Objection to Planning Application Reference 2017/4306/P Arthur Stanley House, 40 - 50 Tottenham Street, London, W1T 4RN (the "Planning Application")

We are instructed by BC Noho Limited (the "**Owner**") the owner of the freehold land shown edged red on the title plan (attached) known as 30 Cleveland Street (the "**Property**"). The development proposed by the Planning Application (the "**Proposed Scheme**") will have a significant adverse impact on the Property and we are instructed to submit an objection on behalf of the Owner.

Plan 1

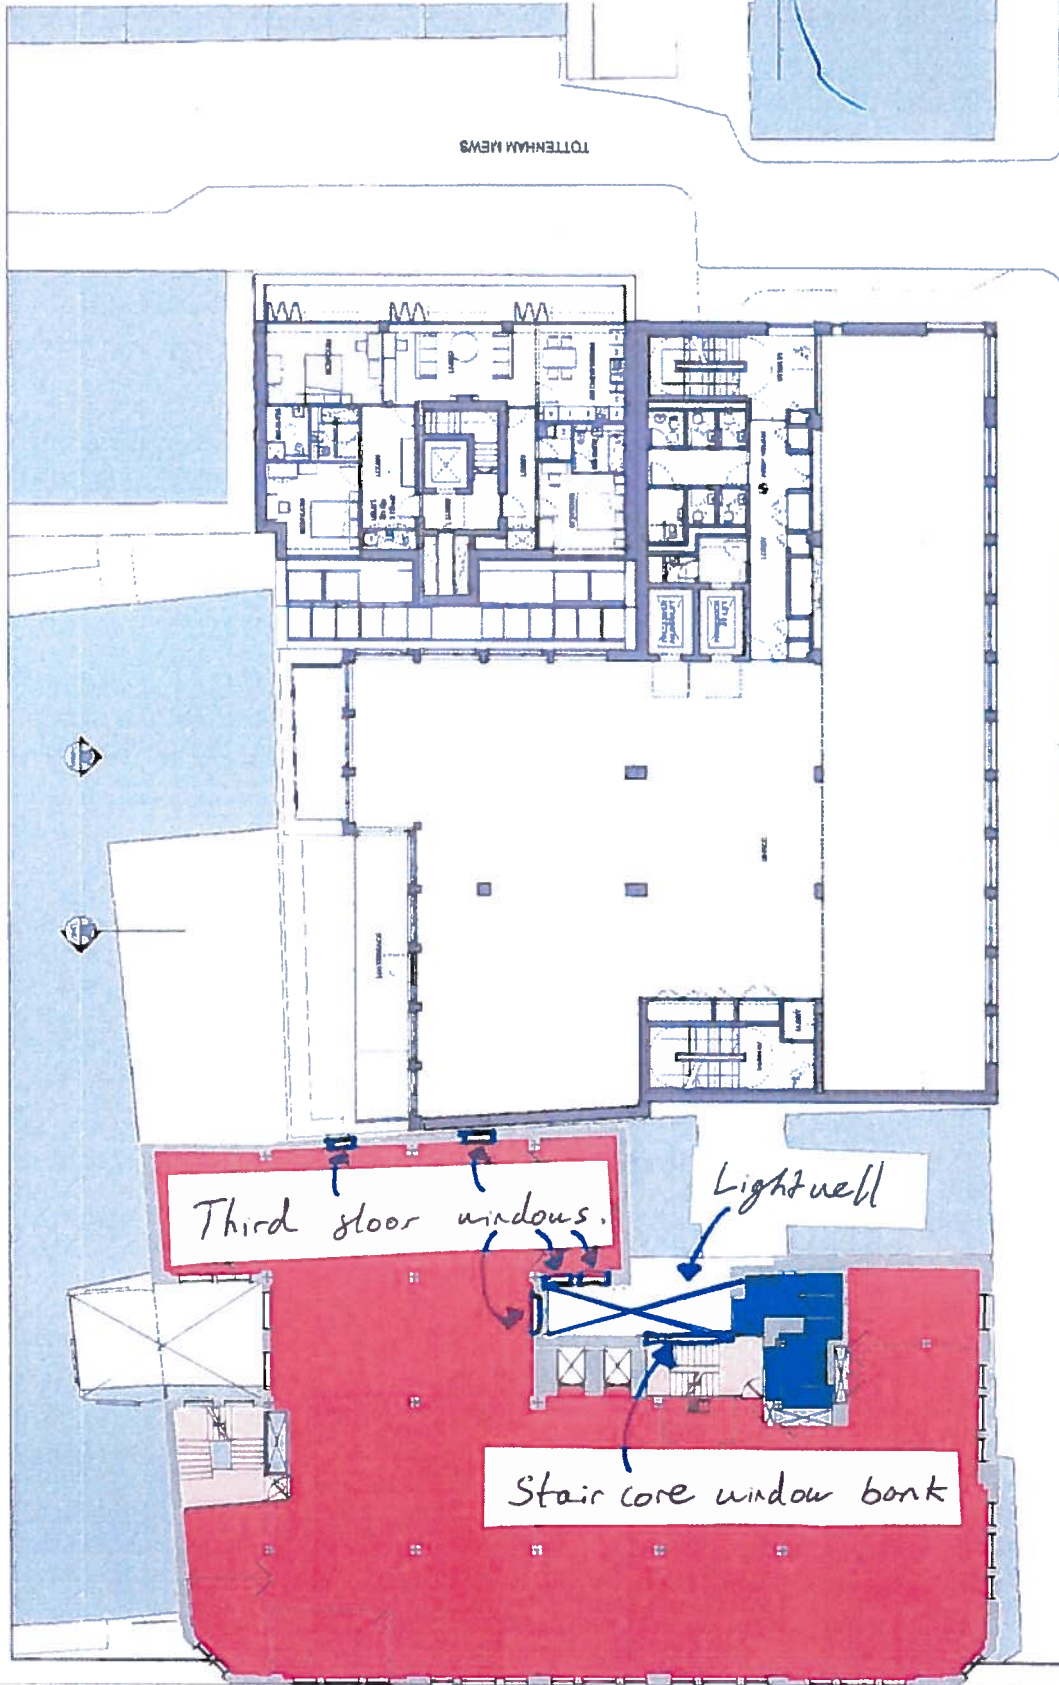
- 1.7 It should also be noted that the 3D images of the Property included in the Daylight and Sunlight Report show the current buildings at the Property but not the Property as developed under the Permission. This is important because additional windows and outdoor terraces will be impacted at the Property when the development pursuant to the Permission is constructed. In addition, they omit existing third floor windows at the Property which will be completely blocked by the rear brick façade of the development pursuant to the Planning Application (see plan 1).

Impact of Proposed Scheme on existing third floor of the Property.

The windows indicated will not receive any light.

Plan 2

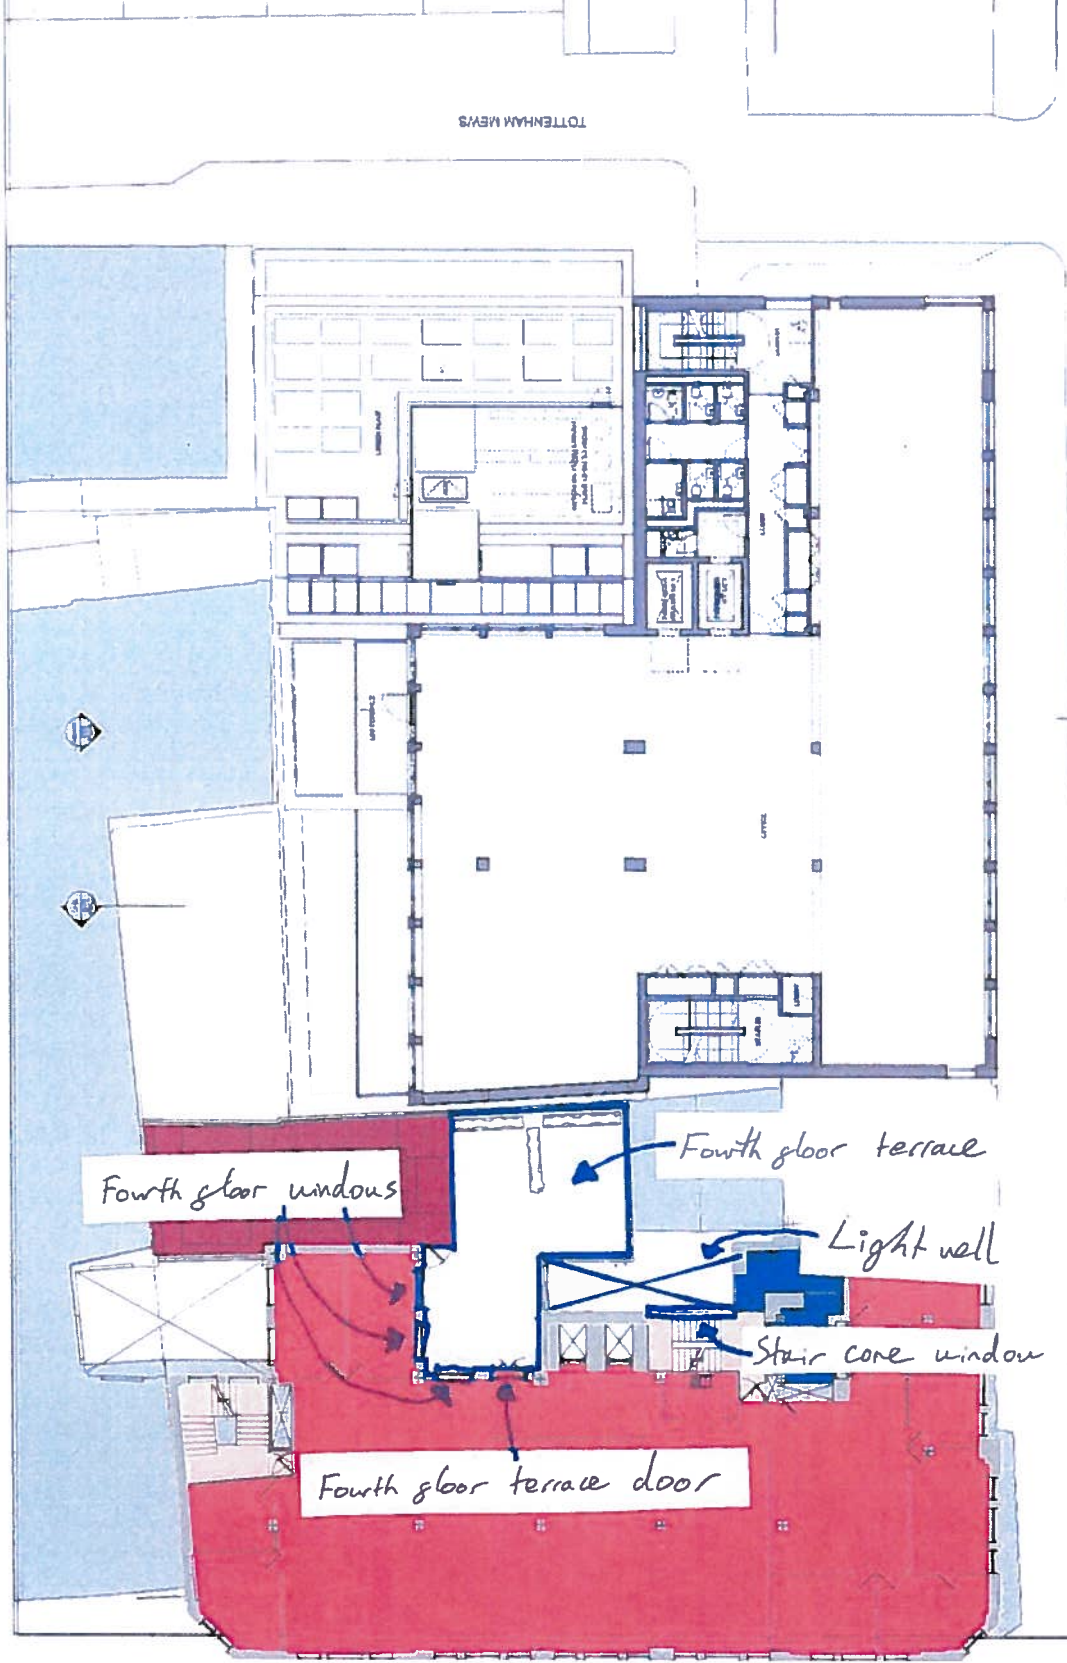
Impact of Proposed Scheme on existing south
floor of the Property.

The windows indicated will be materially and
substantially affected.

Amenity of the terrace will be substantially reduced.

Plan 3

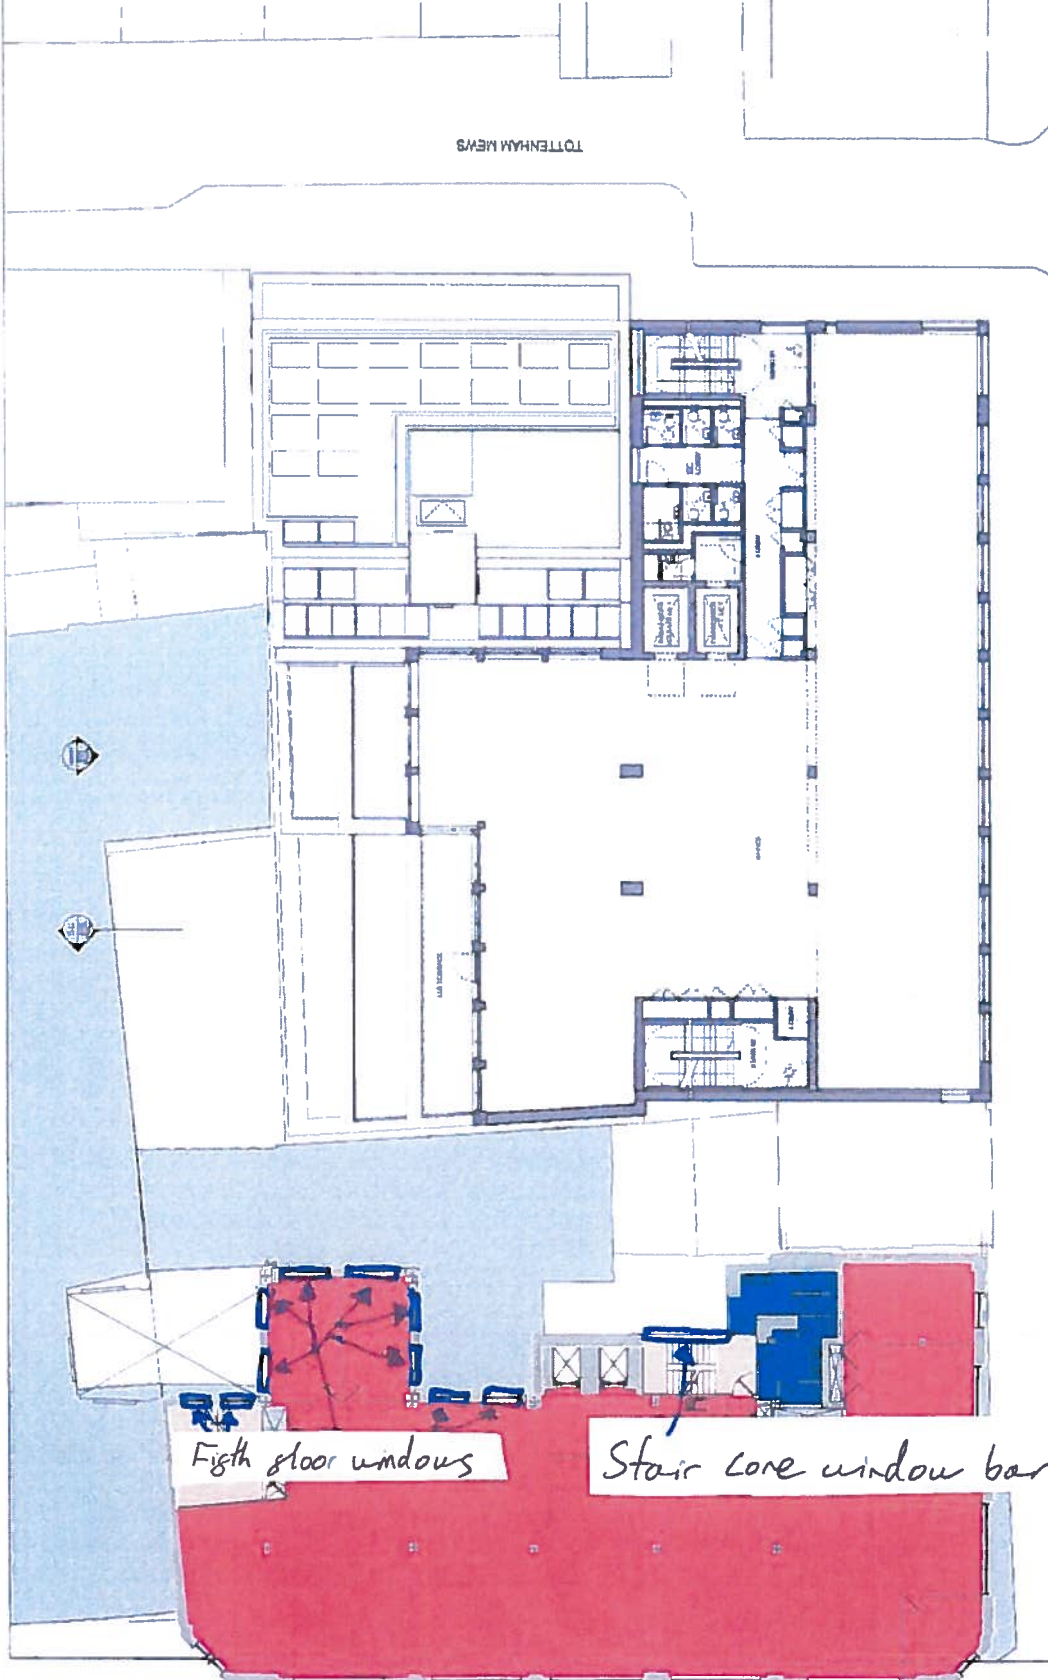
Impact of Proposed Scheme on existing sixth floor of the Property.

The windows indicated will be materially and substantially affected.

Plan 1a
 Impact of Proposed Scheme on the
 scheme for the Property under the Permission,
 third floor.

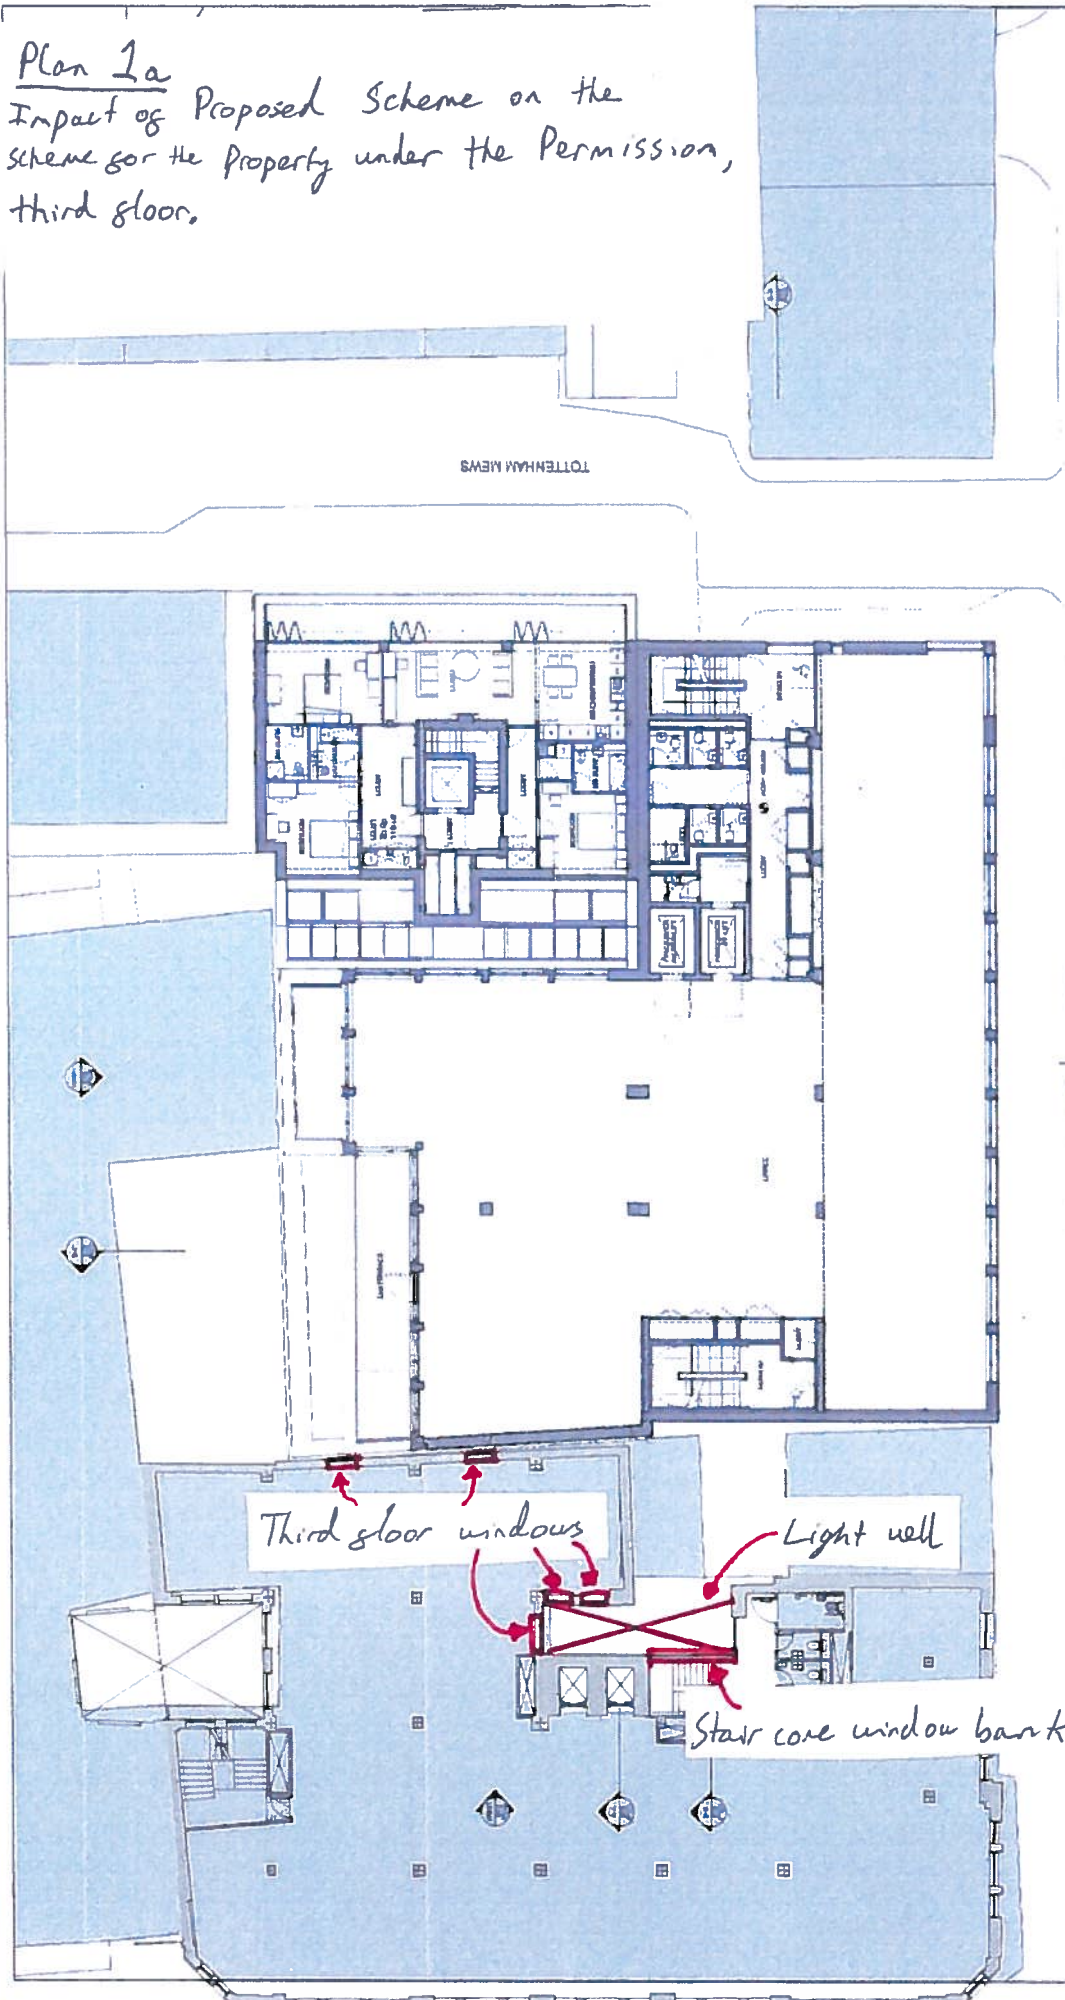
Fifth floor windows
Stair core window bank

Plan 2a

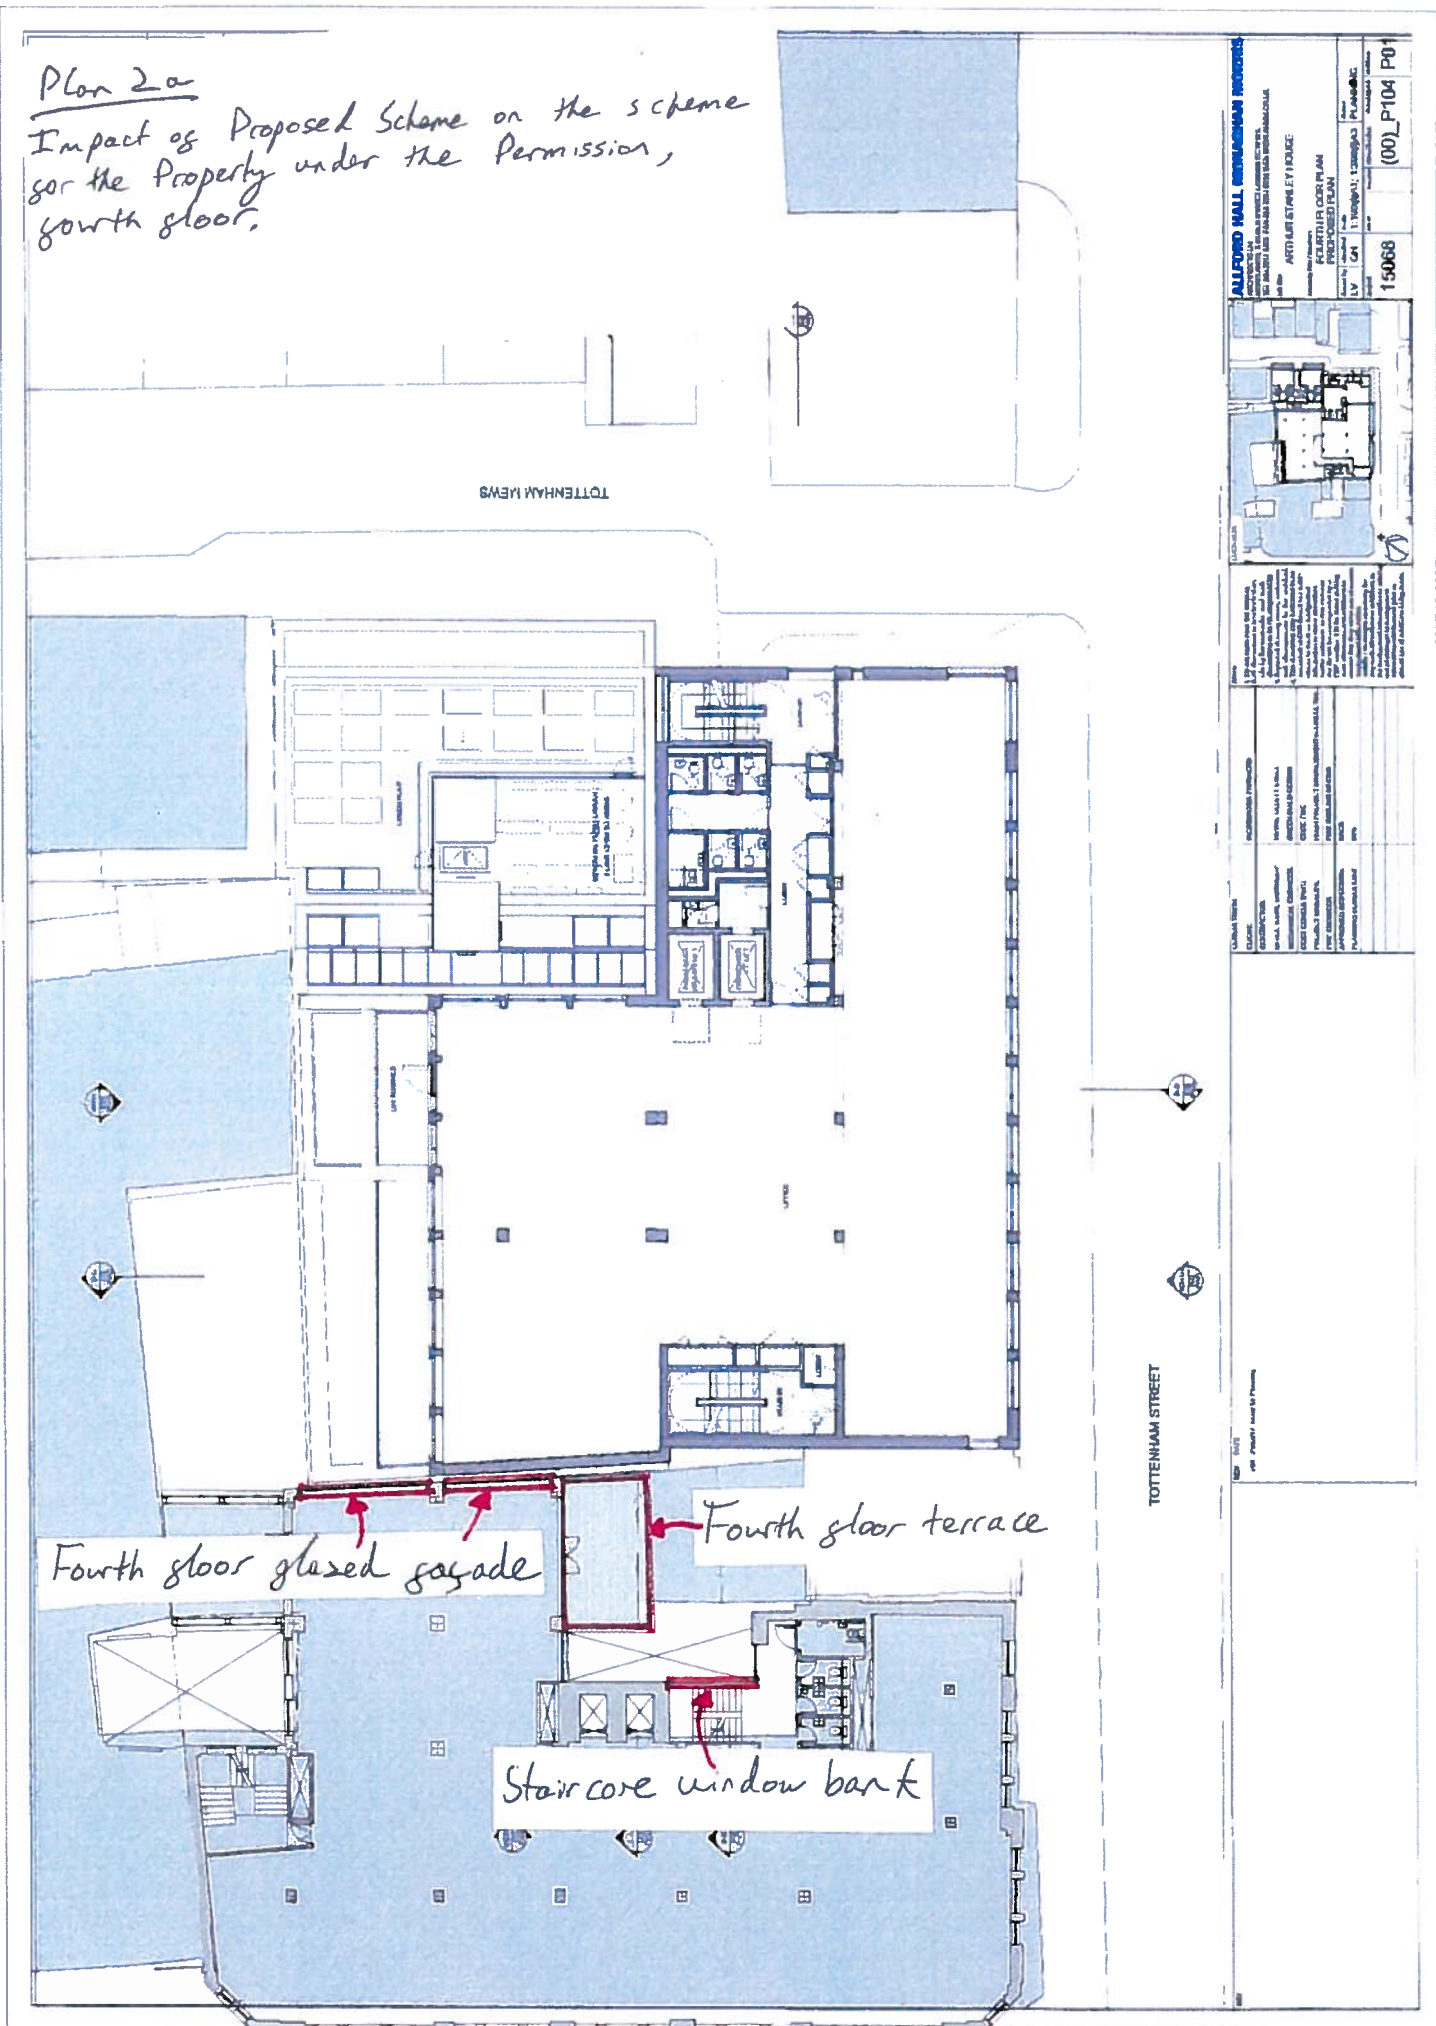
Impact of Proposed Scheme on the scheme for the Property under the Permission, fourth floor.

Fourth floor glazed facade

Fourth floor terrace

Staircore window bank
